Access Compliance Report

Public Rights-of-Way

(Curb Ramps)

Intersection ID: 13442	Main Street: MORRIS_FIELD_DR	Cross Street: AIRPORT_CENTER_PY	Location: SE
ADA ID: 9DC1E9F05A3E	Ramp Type: Perp	Initial Pass/Fail: Fail	Overall Compliance: No
Codes/Mitigation Info/Possible Solution		Field Measurements/Component Compliance	
Severity Score: 21.25

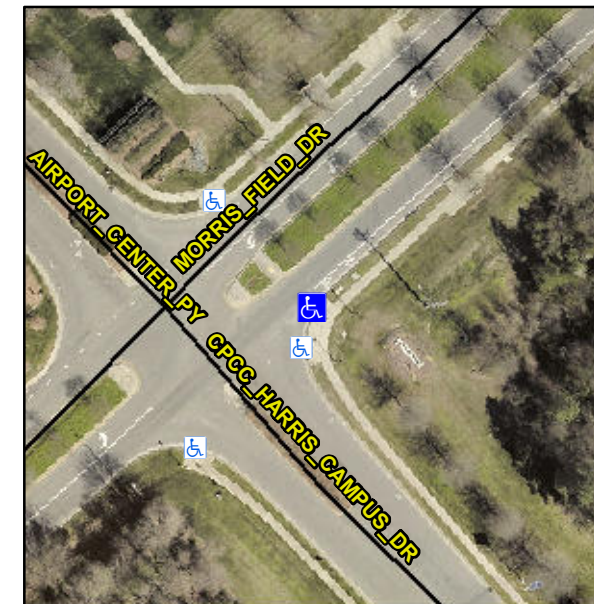
Not Found, R304.5.1, R304.5.3

Compliance	Description	Data	Compliance	Description	Data
N/A	Ramp Length (in)	72.0	Yes	Ramp Slope (%)	6.3
No	Ramp Width (in)	47.0	No	Ramp XSlope (%)	6.4
N/A	Flare Type LT	N/A	N/A	Flare Type RT	N/A
N/A	Flare Slope LT (%)	N/A	N/A	Flare Slope RT (%)	N/A
N/A	Flare Traversable LT?	N/A	N/A	Flare Traversable RT?	N/A
N/A	Landing Length (in)	N/A	N/A	DWS Provided?	N/A
N/A	Landing Width (in)	N/A	N/A	DWS Contrast?	N/A
N/A	Landing Slope (%)	N/A	N/A	DWS Length (in)	N/A
N/A	Landing X Slope (%)	N/A	N/A	DWS Full Width?	N/A
N/A	Landing Curb? (Y/N)	N/A	N/A	DWS Offset (in)	N/A
N/A	Shared Landing?	N/A			
N/A	Gutter Ponding?	N/A	N/A	Gutter Slope (%)	N/A
N/A	Gutter Lip Ht (in)	N/A	N/A	Gutter X Slope (%)	N/A
N/A	Painted X Walk1?	No	N/A	Painted X Walk2?	N/A
	X Walk 1 Direction	To NW		X Walk 2 Direction	N/A
N/A	X Walk 1 Width (in)	N/A	N/A	X Walk 2 Width (in)	N/A
	X Walk 1 Slope (%)	0.8		X Walk 2 Slope (%)	N/A
	X Walk 1 X Slope (%)	2.7		X Walk 2 X Slope (%)	N/A

Remove & Replace Entire Ramp.
